Field Notes

PROJECT NO. P402230034

BRIDGE NO. LUC-2-1862

West Suspension Span
Elevation - Floorbeam 39

West Suspension Span
Elevation - Floorbeam 47

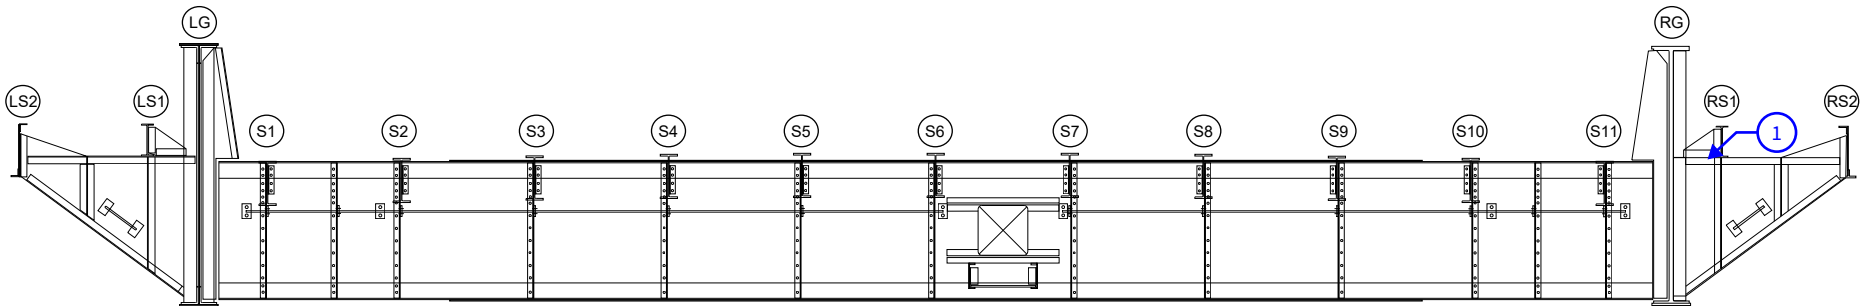
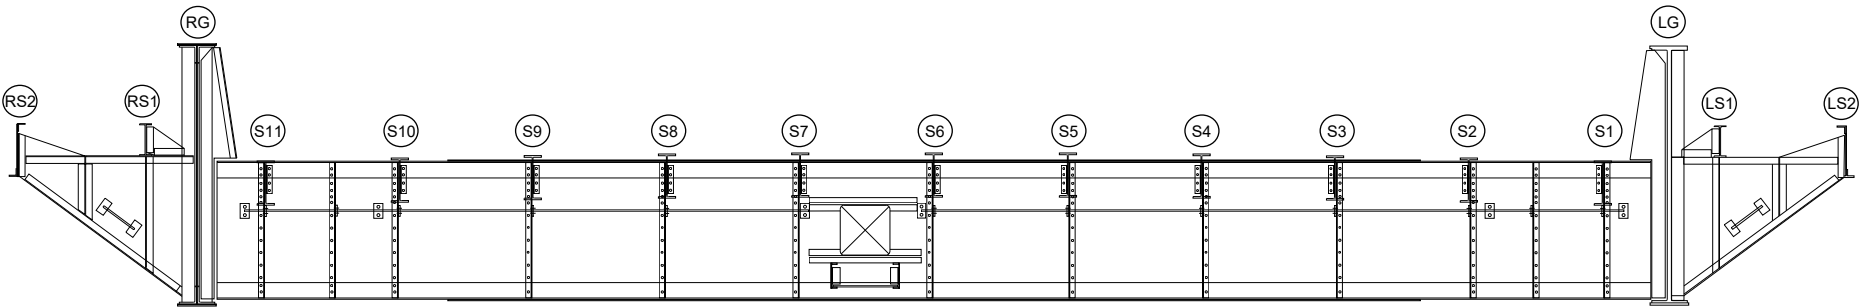
① Floorbeam - sidewalk cantilever top flange cracked

West Suspension Span
Elevation - Floorbeam 50

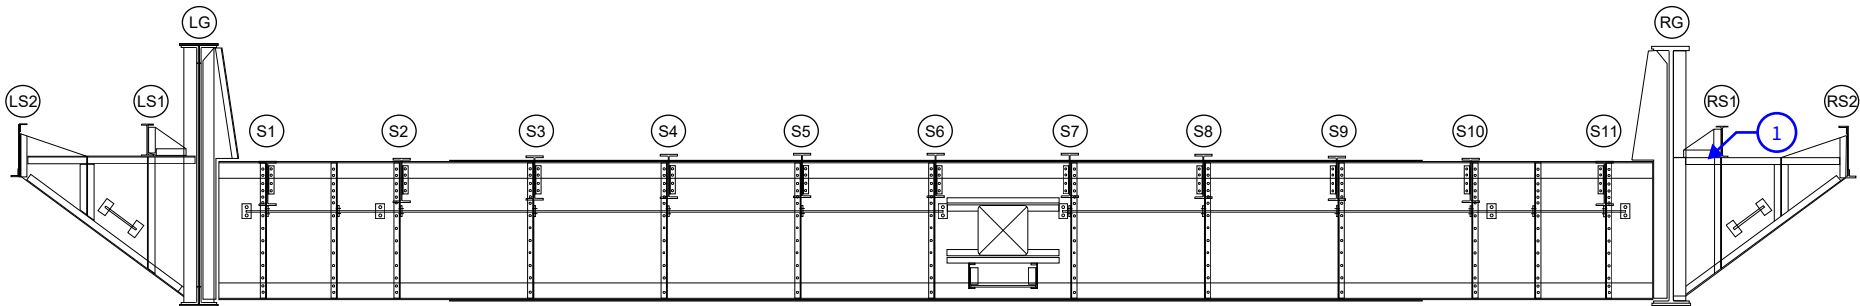
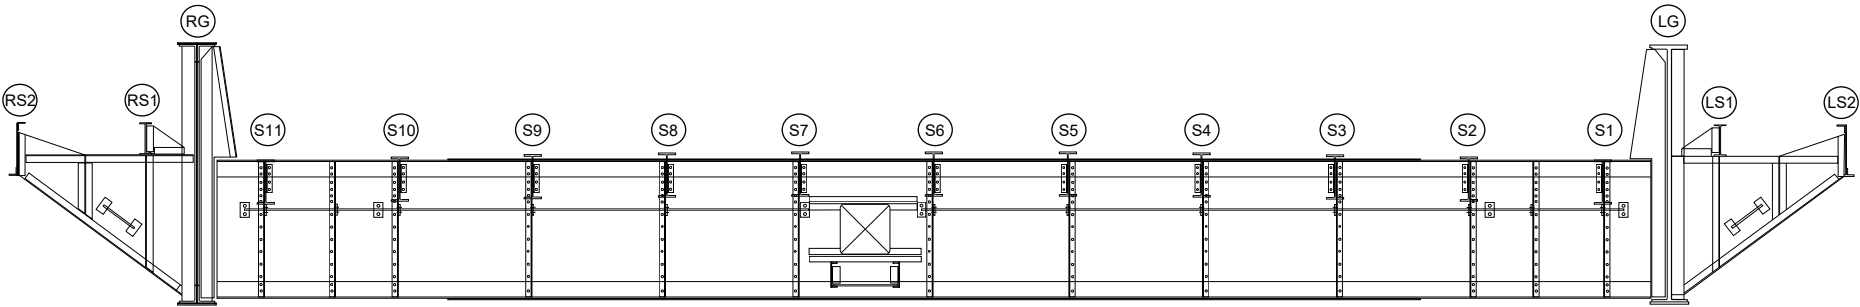
① Floorbeam - sidewalk cantilever top flange cracked

West Suspension Span
Elevation - Floorbeam 51

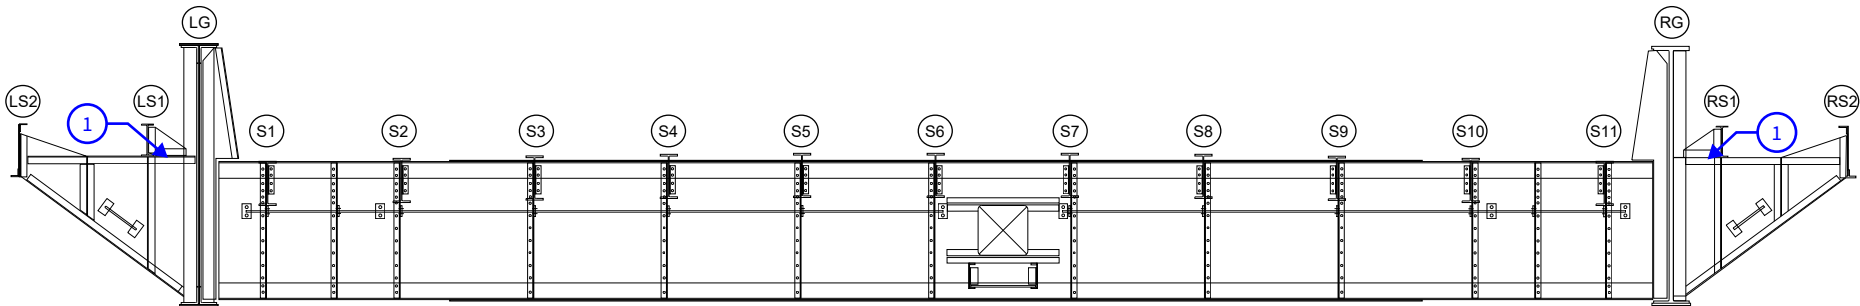
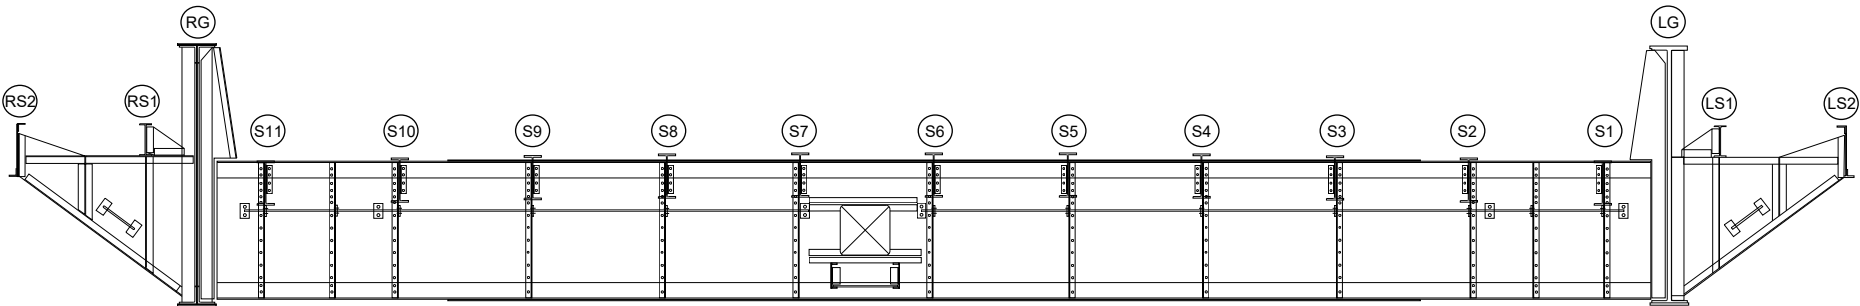
① Floorbeam - sidewalk cantilever top flange cracked
